#### SUBDIVISION REVIEW SHEET

CASE NO.: C8J-2021-0080.0ACOMMISSION DATE: May 24, 2022SUBDIVISION NAME: Whisper Valley Multifami> Parcel 65 Preliminary PlanADDRESS: 17001 E Braker LaneAPPLICANT: Club Deal 120 Whisper Valley, L.P.AGENT: Land Dev Consulting (Michael Giannetta)ZONING: Whisper Valley PUDMEIGHBORHOOD PLAN: N/AAREA: 16.2 acresCOUNTY: TravisMATERSHED: Gilleland CreekJURISDICTION: Limited Purpose

CITY OF AUSTIN – TRAVIS COUNTY – SINGLE SUBDIVISION OFFICE SUBDIVISION APPLICATION – MASTER COMMENT REPORT

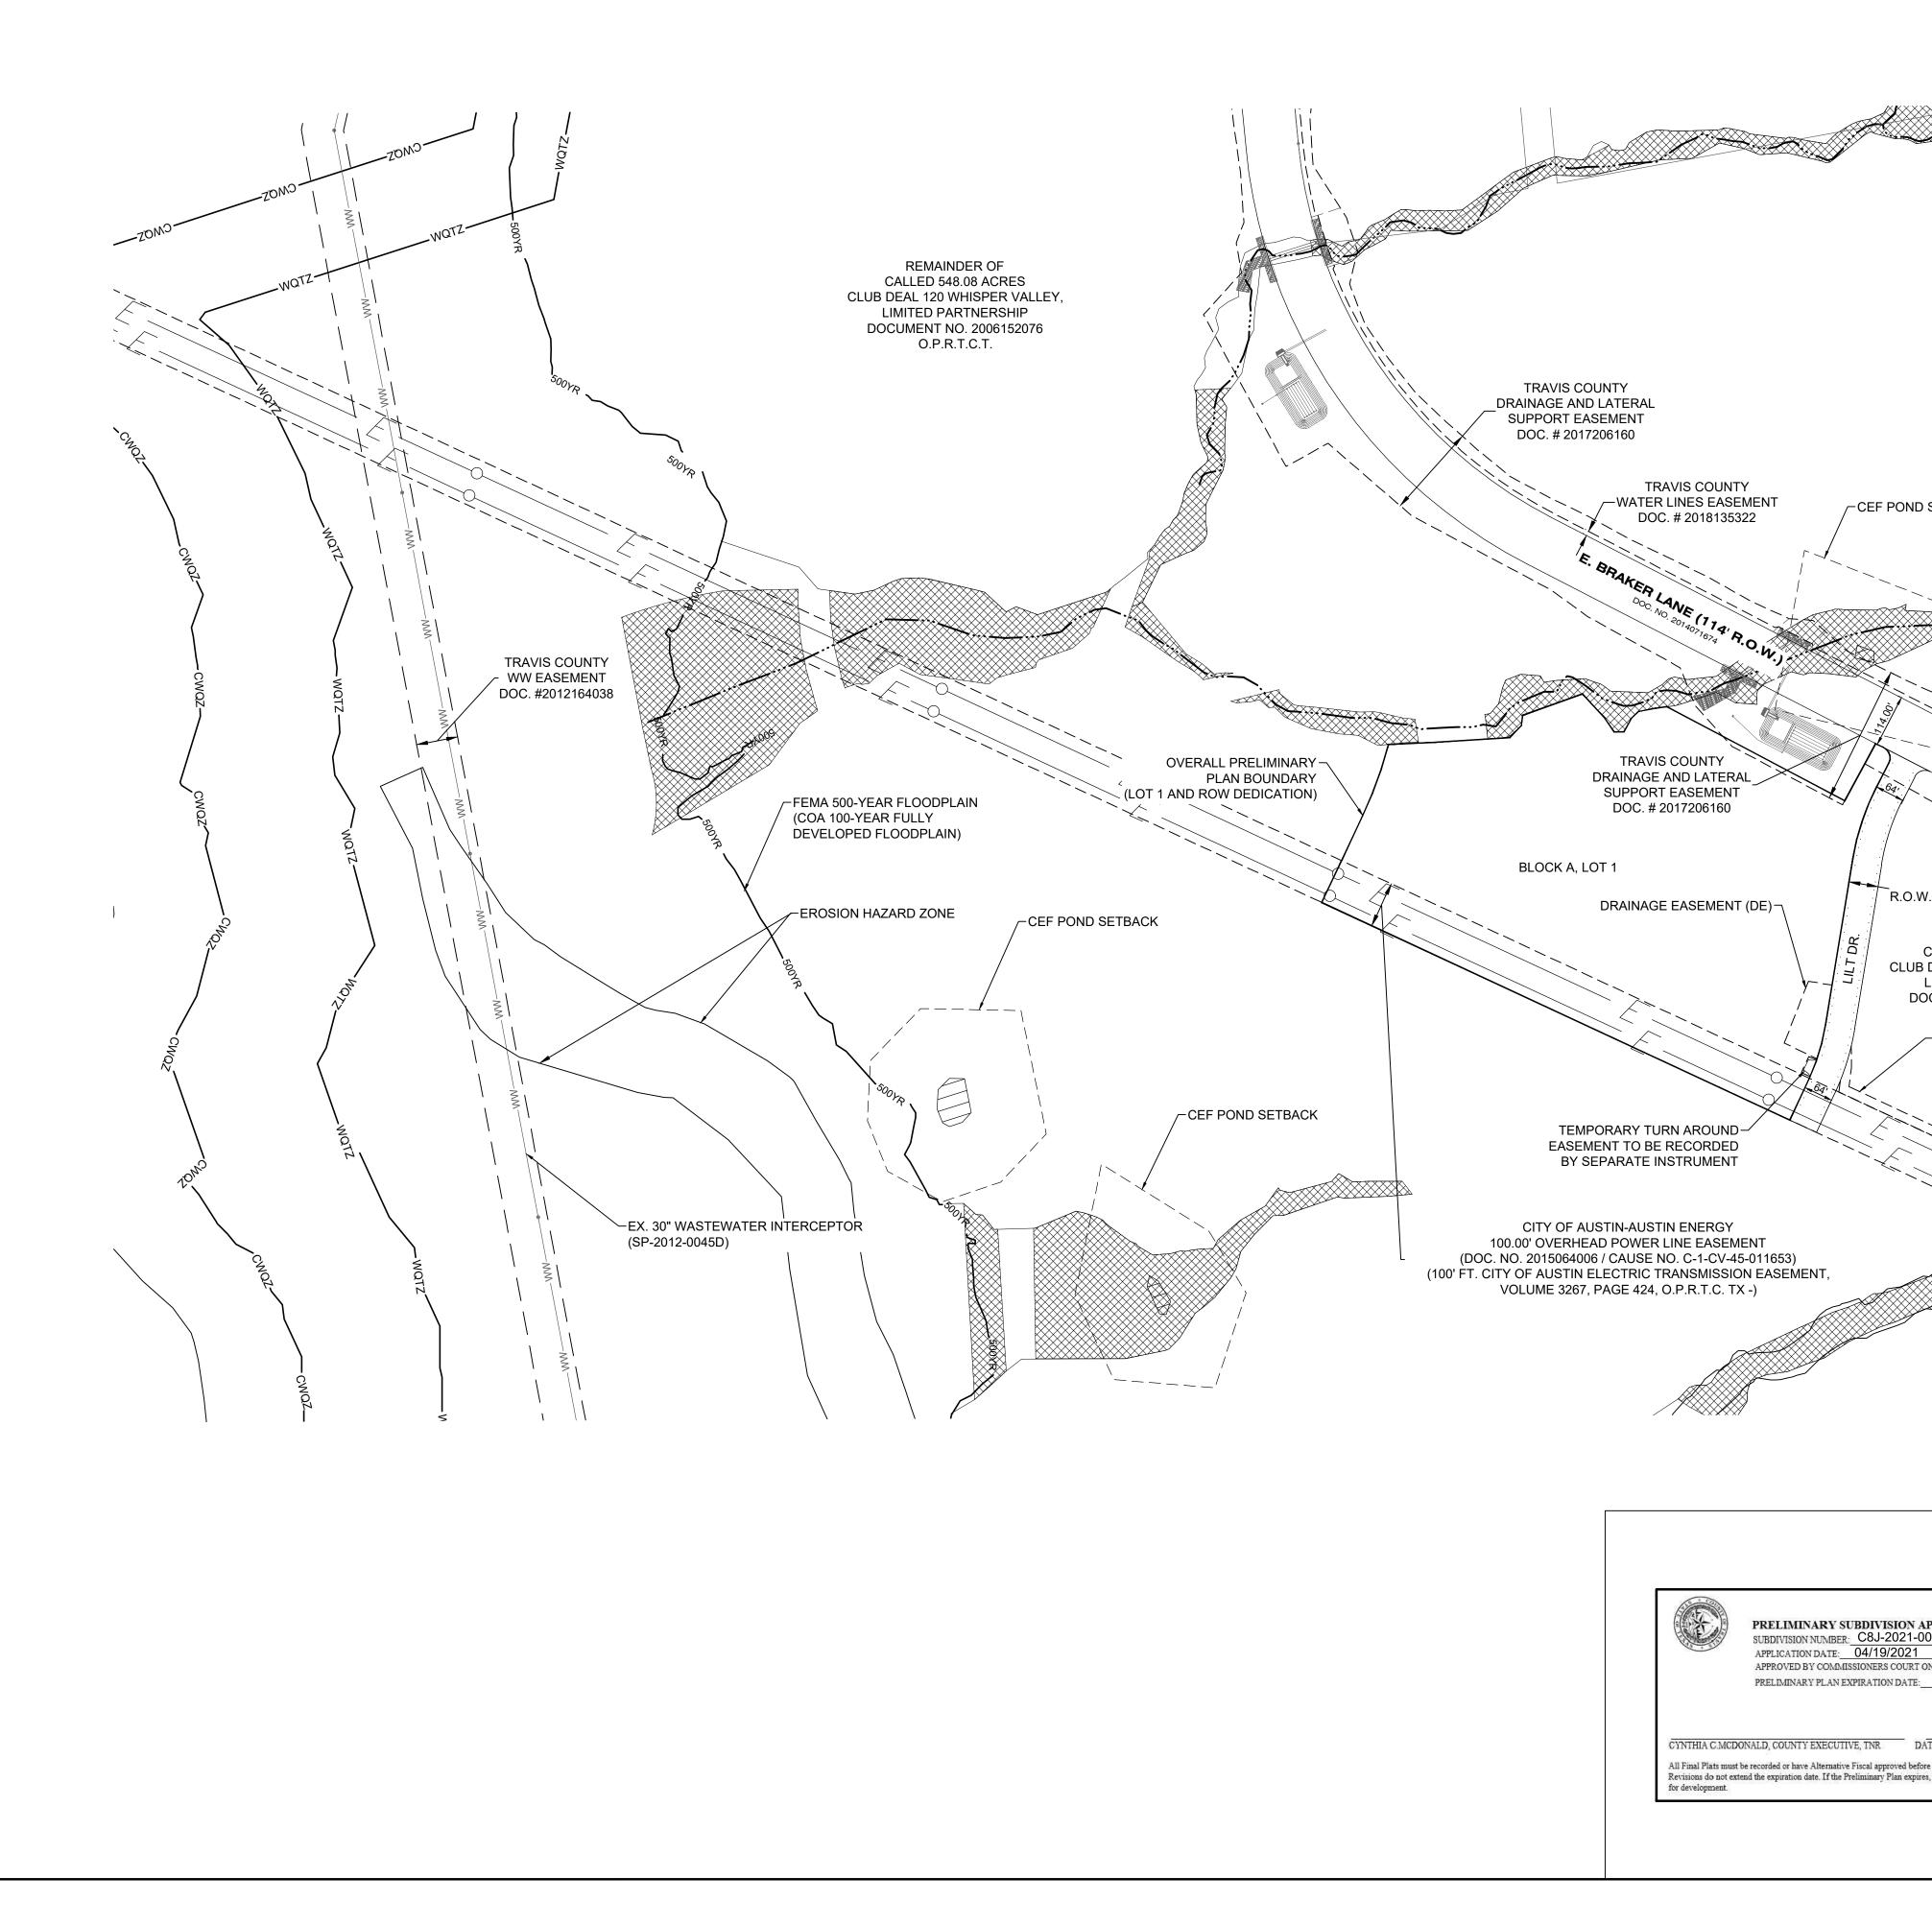
- TR 1. General Note No.20 on Sheet 2 refers to Petrichor Drive and other streets not in this Preliminary Plan, please update this note to reflect the street names within this Preliminary Plan.
- TR 2. Indicate that the temporary turnaround easement will be dedicated by separate instrument. A draft of the proposed easement will need to be provided for review with the final plat, and a fully executed copy provided for recordation simultaneously with the final plat.
- TR 3. Thank you for acknowledging that the TIA review, and related Traffic Mitigation or Phasing Agreement, will need to be complete prior to the approval of this Preliminary Plan. Informational: TIA and related mitigation agreement will need to be completed prior to approval of the Preliminary Plan.
